When diagnosing a customer complaint of a creaking or popping noise coming from the front suspension while accelerating or decelerating, inspect the two (2) rearmost sub-frame bolts (A) to verify the correct bolt was installed during assembly. The correct bolt should have a raised hexagonal crown and an irregularly-shaped flange (Fig B). If the incorrect bolt is found to be installed, remove and replace using P/N 62492 C5000.

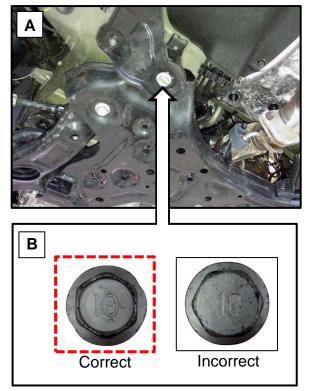
Additionally, if the vehicle was produced prior to February 25, 2015, inspect the top strut nut (C) for proper torque.

## Tightening torque: 43.4 ~ 50.6 lb·ft (58.8 ~ 68.6 N·m)

Tightening torque: 39.8 ~ 54.2 lb·ft (53.9 ~ 73.5 N·m)
